Request for Proposal (RFP)  
 Bid No: Bid 26-05-4136SB  
 Addendum No. 3

**Date:** June 19, 2026  
**To:** All Proposers  
**Subject:** Addendum No. 3  
 Consisting of Seventeen (17) Pages  
**RFP No.:** Bid 26-05-4136SB  
**Project Name:** N9073(1)1,2&4 Blue Canyon Road Project in Apache County, AZ  
**Owner:** Navajo Division of Transportation

## Addendum No. 3

NOTE:  
THIS DETAIL IS IN CUSTOMARY UNITS.

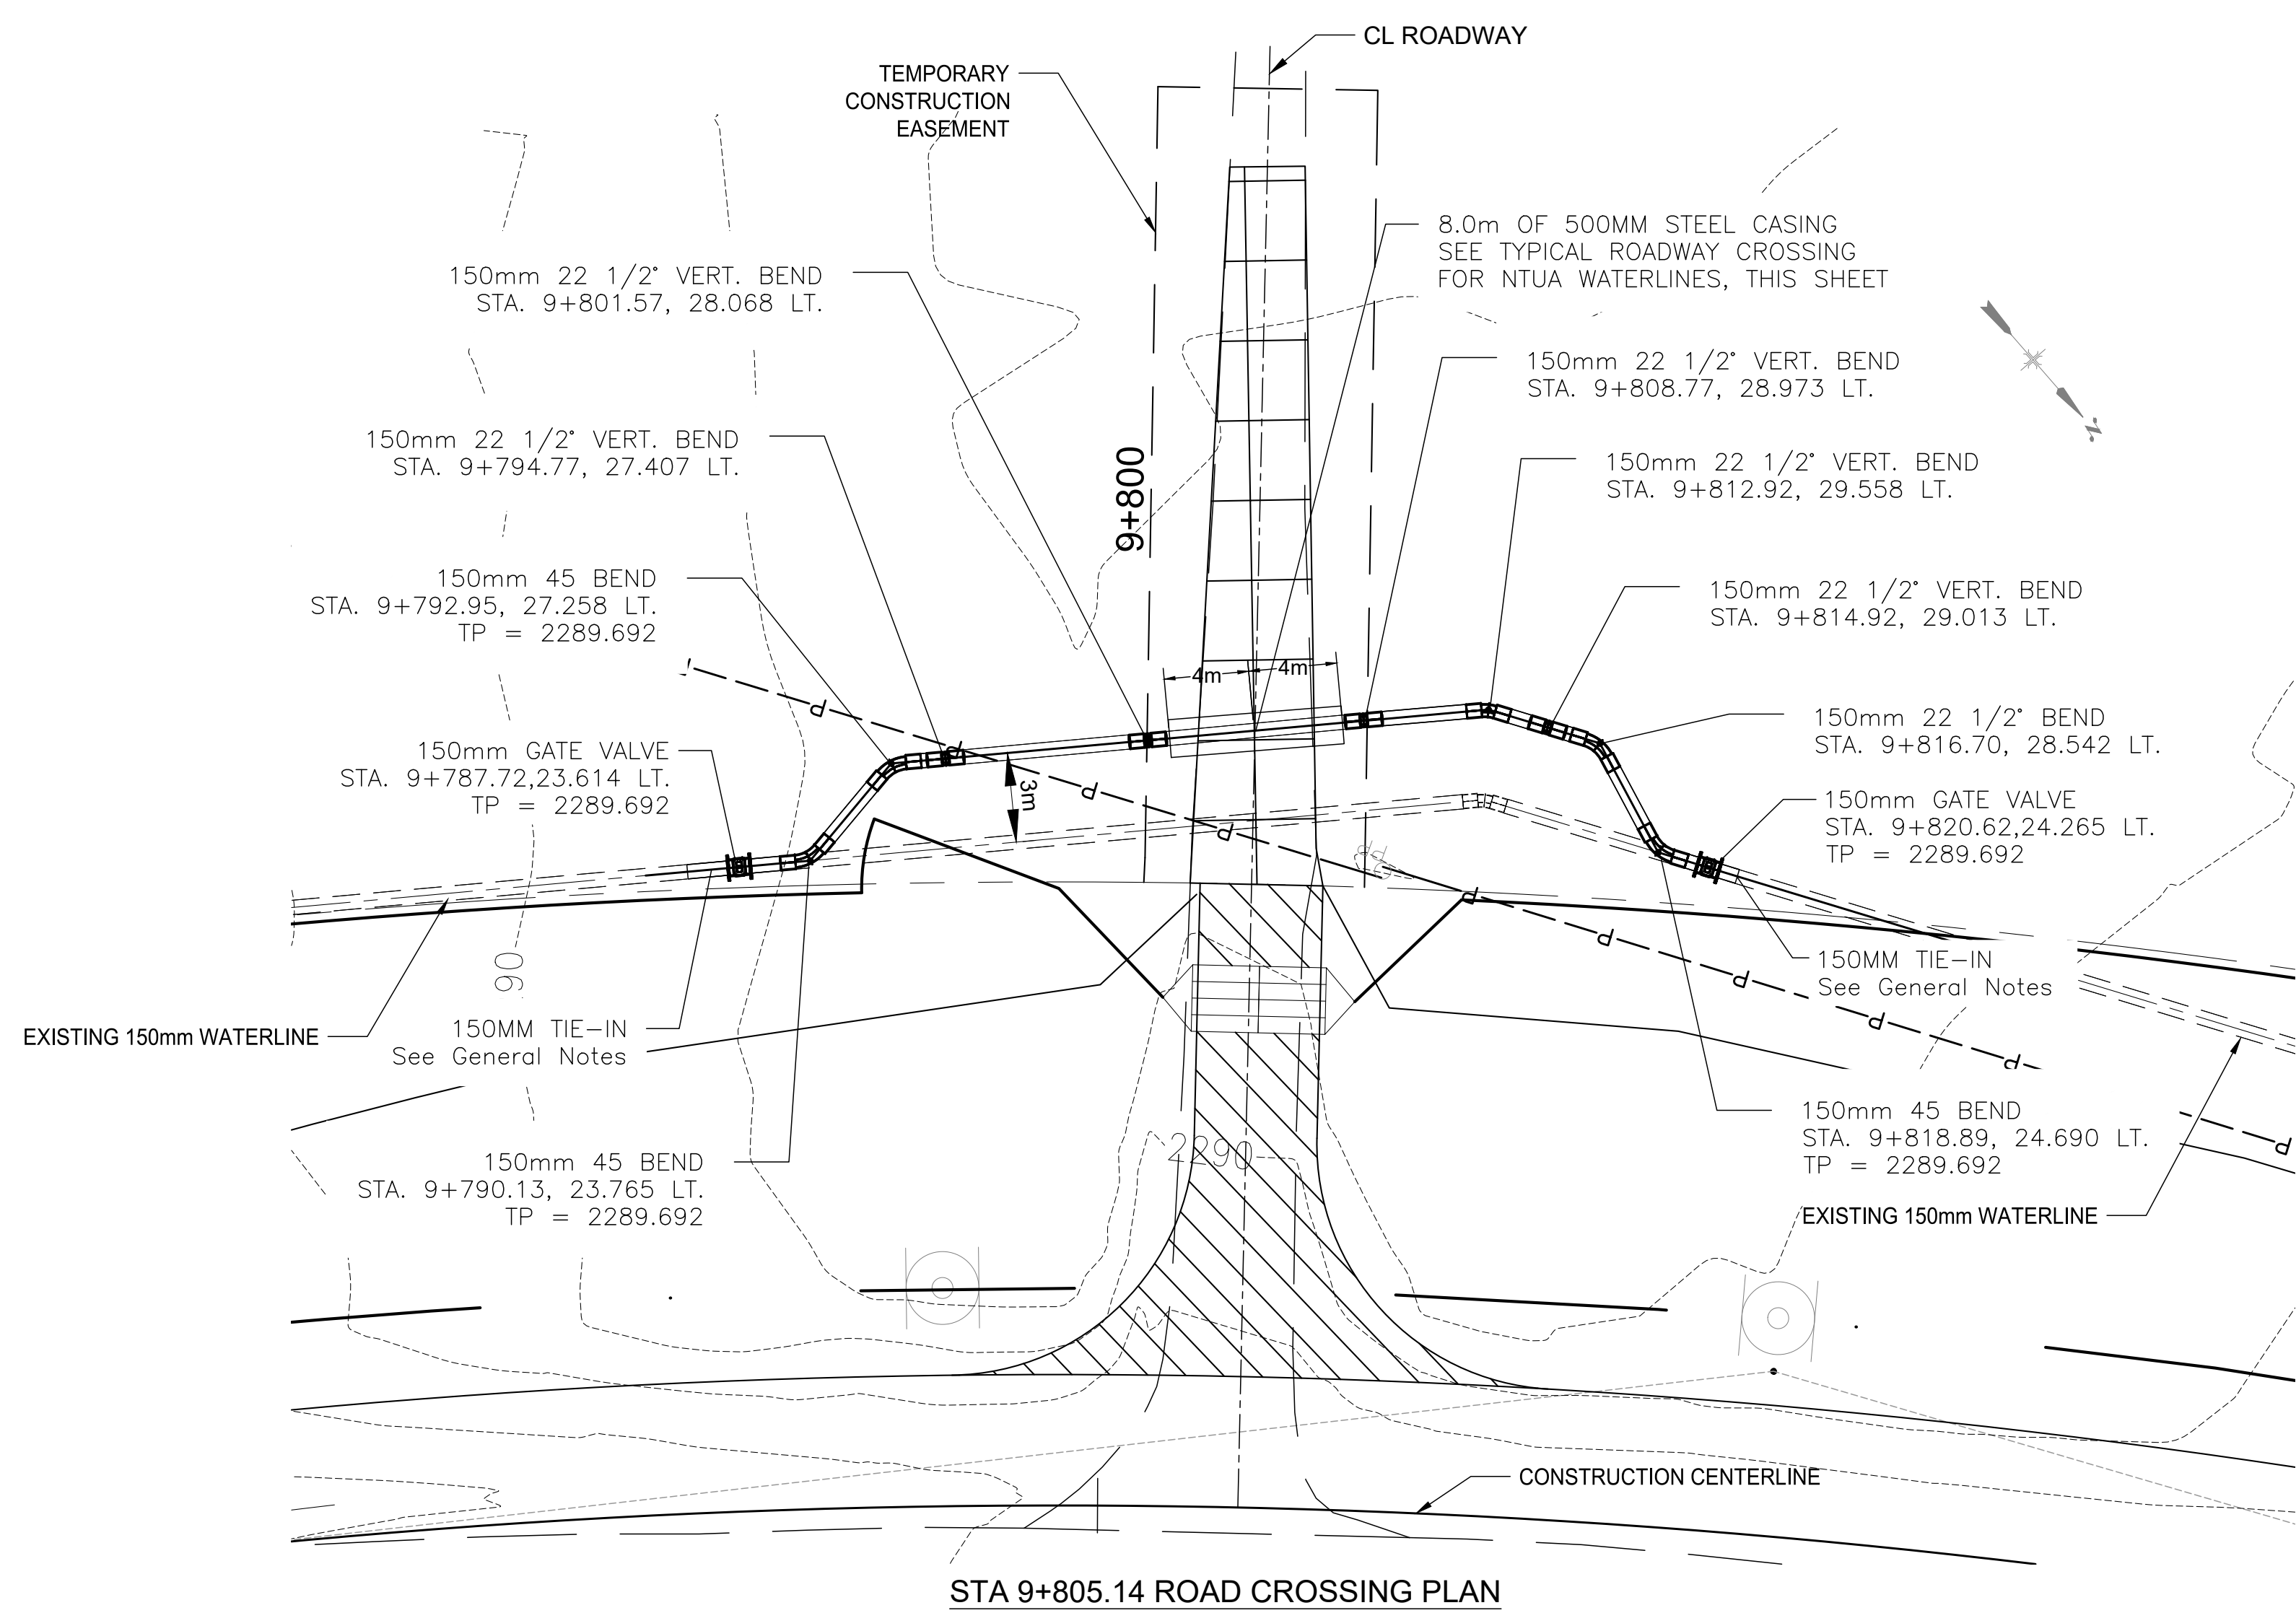
- The overall plans are being reviewed, and design revisions to the earthwork are being implemented. These implementations will be in a forthcoming addendum #4.
- Sheet 7 ESTIMATED QUANTITIES TABLES:
  - Revised to update the quantity for Bid Item No. 25302-100 Gabions, Aluminized Coated, Class 2 to 9,335 m<sup>3</sup>.
  - Revised for the updated NTUA waterline relocation design.
- Sheet 33A: Revised to update the quantity for Bid Item No. 25302-100 Gabions, Aluminized Coated, Class 2 to 9,335 m<sup>3</sup>, removing segment 2.
- Sheets 77-80: Revised for the updated NTUA waterline relocation design.
